27 August 2013

RE: LAKE MACQUARIE YACHT CLUB - SECTION 75W APPLICATION TO AMEND MAJOR PROJECT APPROVAL 08 0045

Following our meeting with you and Chris Ritchie on 15 August 2013, please find enclosed for your consideration an application made under Section 75W of the Environmental Planning and Assessment Act 1979, to modify the Part 3A project approval 08_0045 to redevelop Lake Macquarie Yacht Club. Specifically the approval was for the following:

Proposed Stage 1 Site Plan

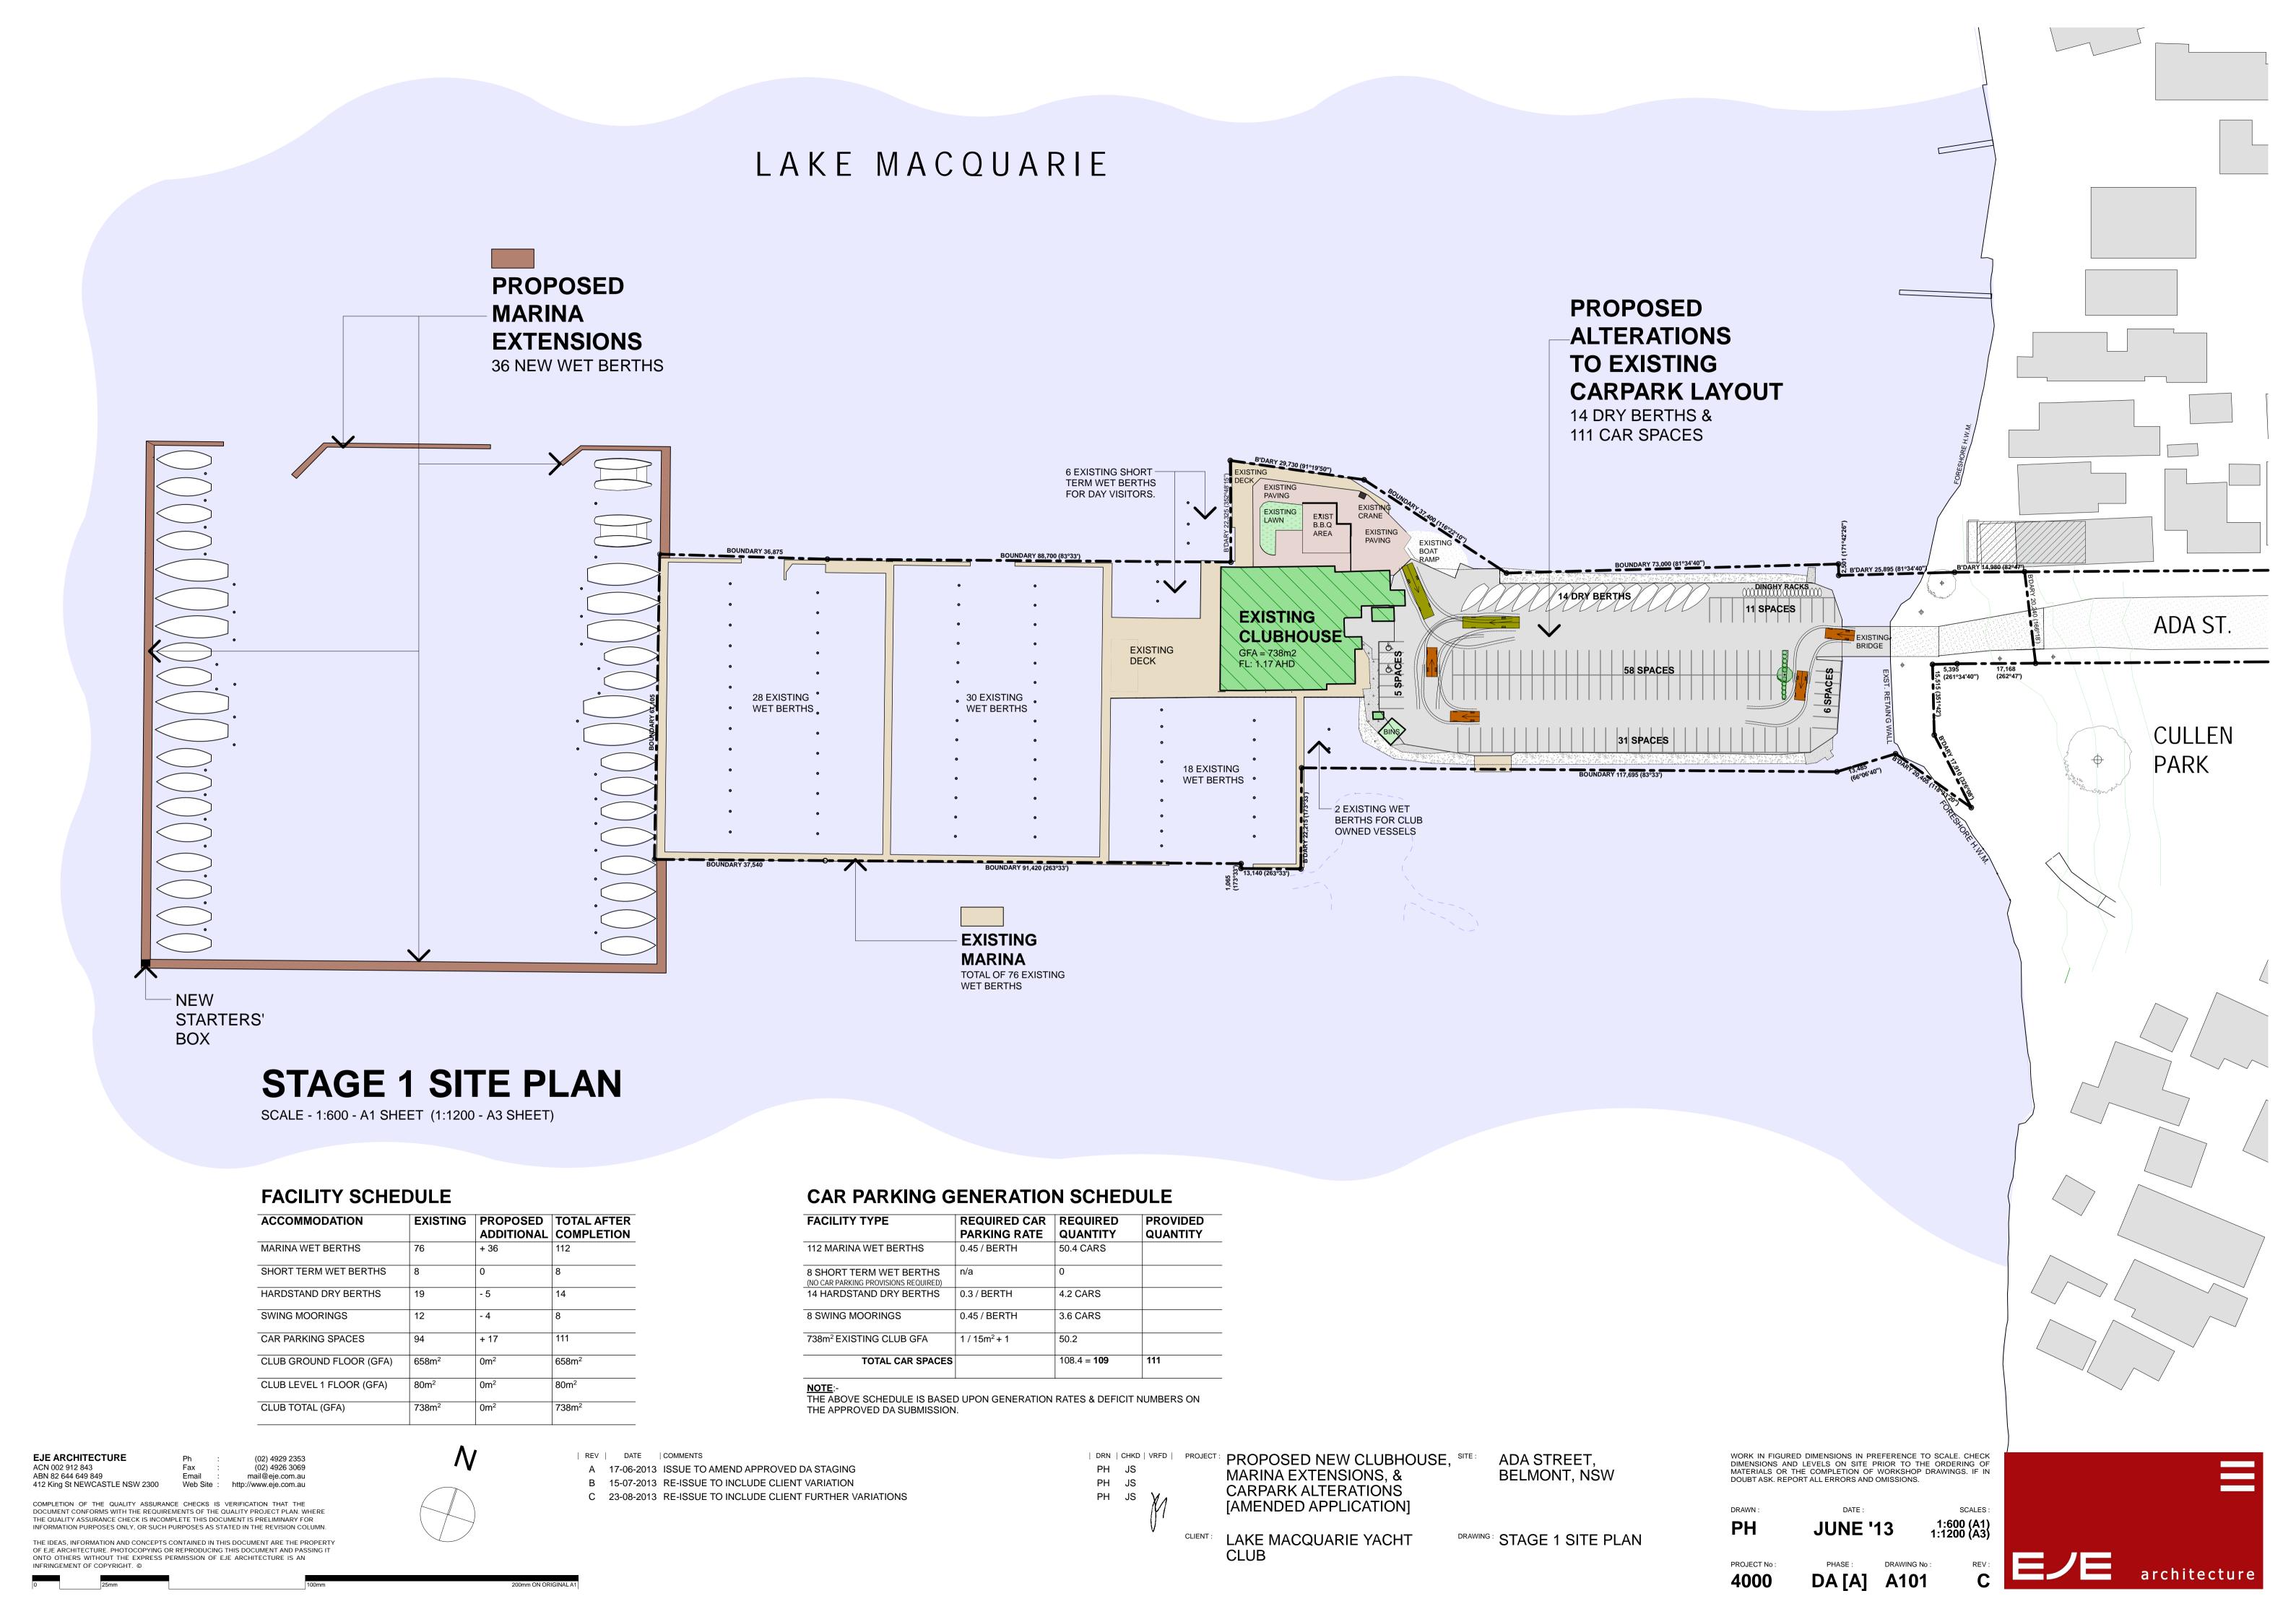
- Reduce the overall number of wet berths to be constructed at this stage from 148 (approved) to 112 whilst retaining 8 existing commercial swing moorings. The reduction would be achieved by deferring the construction of the central finger of the new marina to Stage 2;
- Provide 14 hardstand dry berths;
- Provide infrastructure and services associated with the proposed works;

• Reconfigure parking on the existing pontoon to accommodate 111 spaces (refer drawing at **Attachment 3**) based on the following parking requirements;

- Increase the number of wet berths to be constructed at this stage from 112 to 140 whilst retaining 8 existing commercial swing moorings. The increase would be achieved by constructing the central finger of the new marina;
- Reduce the number of hardstand dry berths from 14 to 8;
- Provide infrastructure and services associated with the proposed works;
- Reconfigure parking on the existing pontoon to accommodate 120 spaces (refer drawing at **Attachment 4**) based on the following parking requirements;

Proposed Stage 3 Site Plan

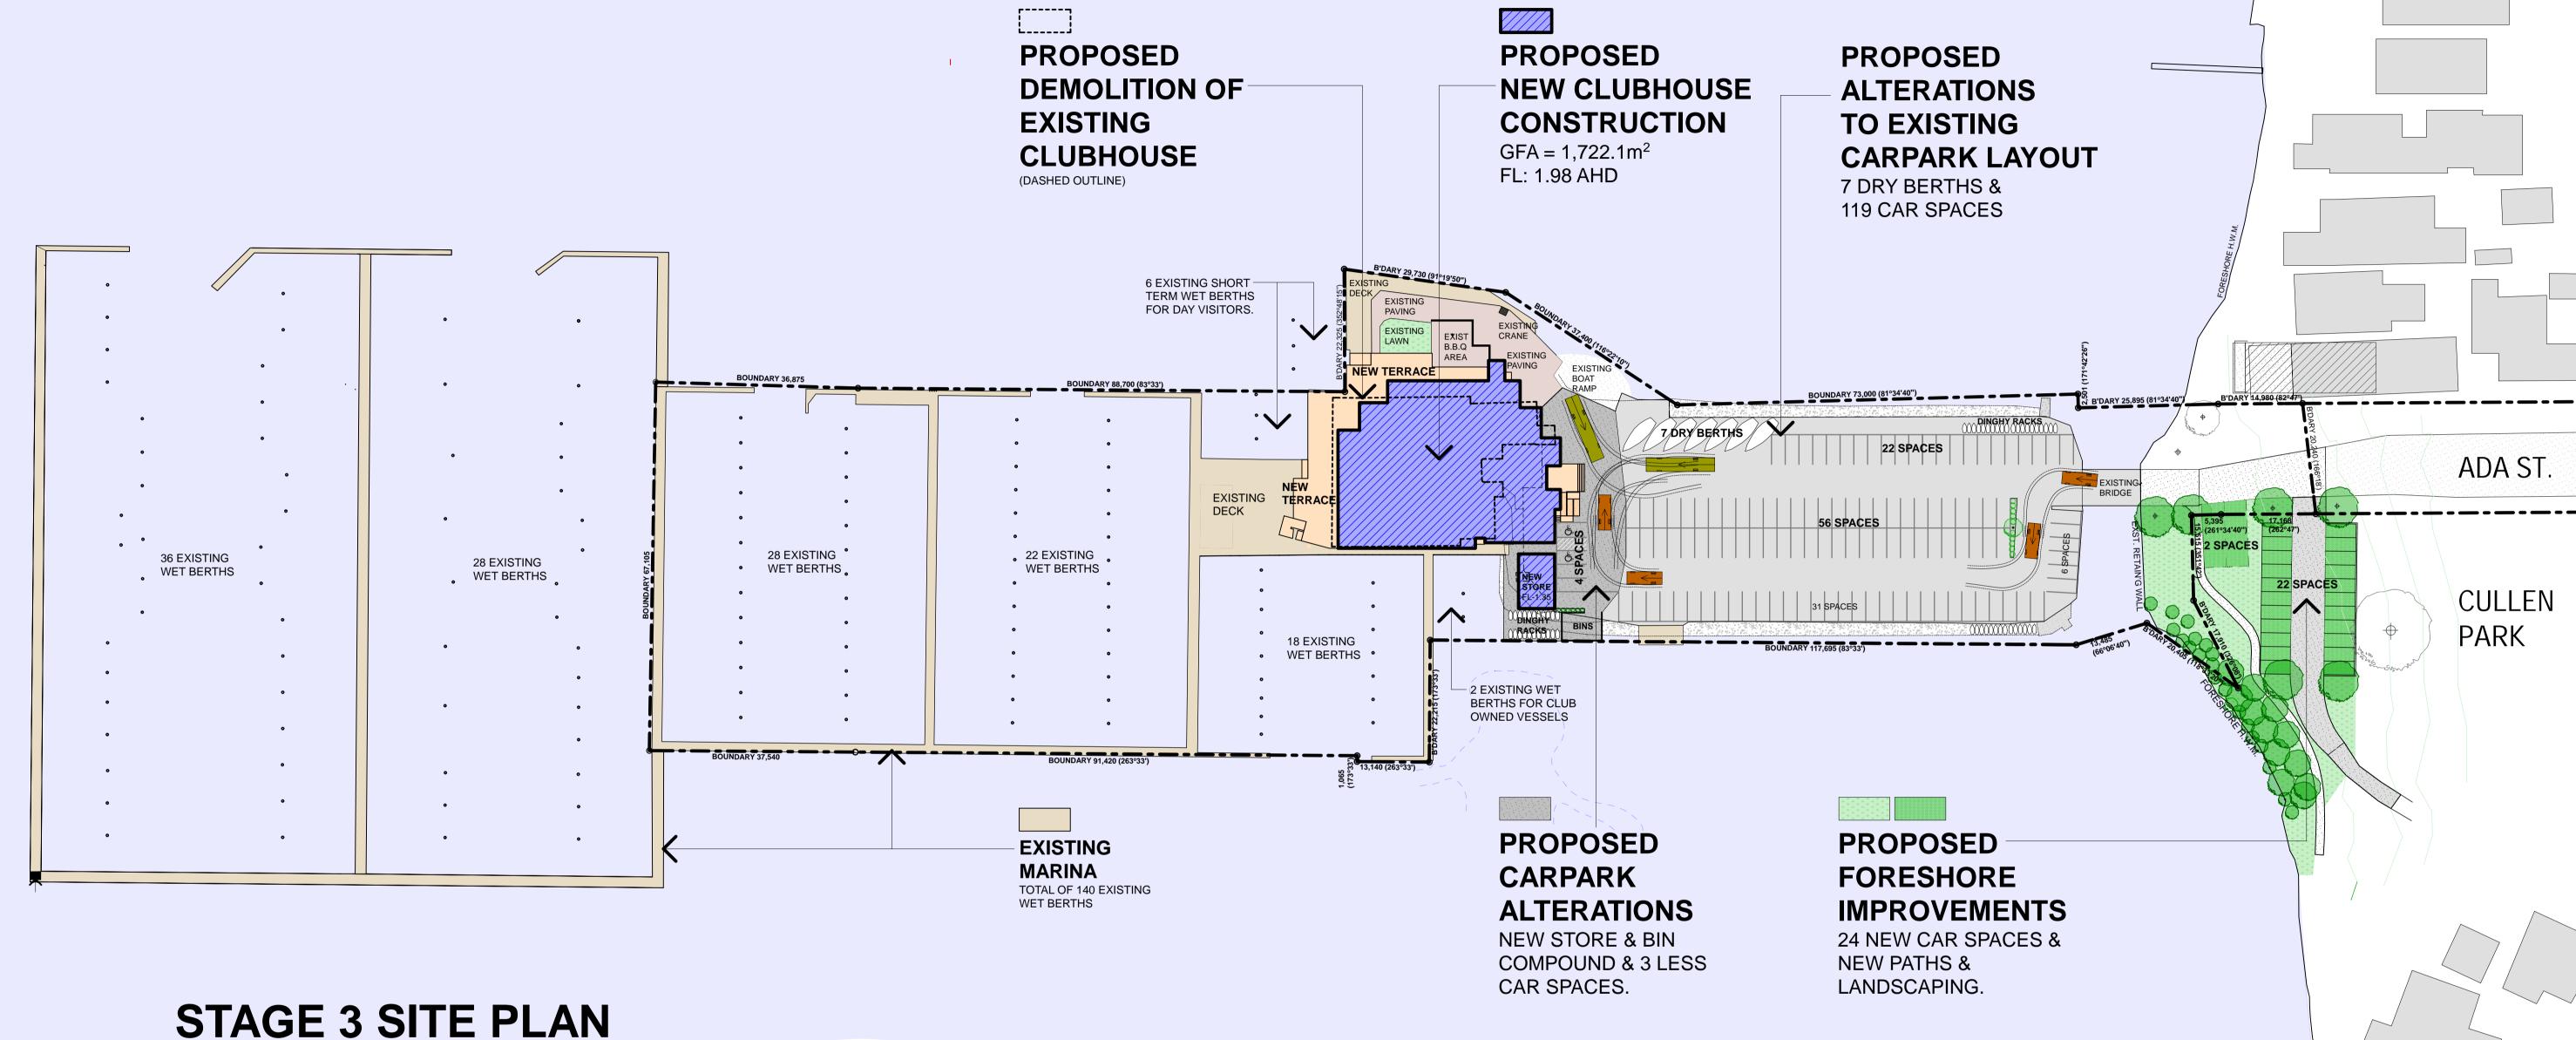
- Construct new club building;
- Carry out public domain improvements to Cullen Park including provision of formalised parking areas (24 spaces) and landscaping improvements;
- Carry out road works along Ada Street including provision of 18 additional car spaces bringing total number of car spaces provided to 162;
- Remove 8 swing moorings;
- Total number of car spaces required to be provided is as follows (refer drawing at Attachment
 5):

It should be noted that Drawing A10 Revision C (existing approval) shows a total of 151 car spaces, including 127 spaces located on the existing pontoon as well as 22 car spaces and 2 trailer spaces located on at Cullen Park foreshore reserve. This resulted in an agreed parking deficiency (excluding Ada Street) of 31 spaces.

The overall net effect of the proposed change at the end of Stage 3 is a reduction of 12 berths (requiring 12x 0.45 = 5.4 car parks) and 8 swing moorings (requiring 8x0.45 = 3.6 car parks) or 9 car spaces in total. The overall number of car spaces is proposed to be reduced by 7 from 169 to 162.
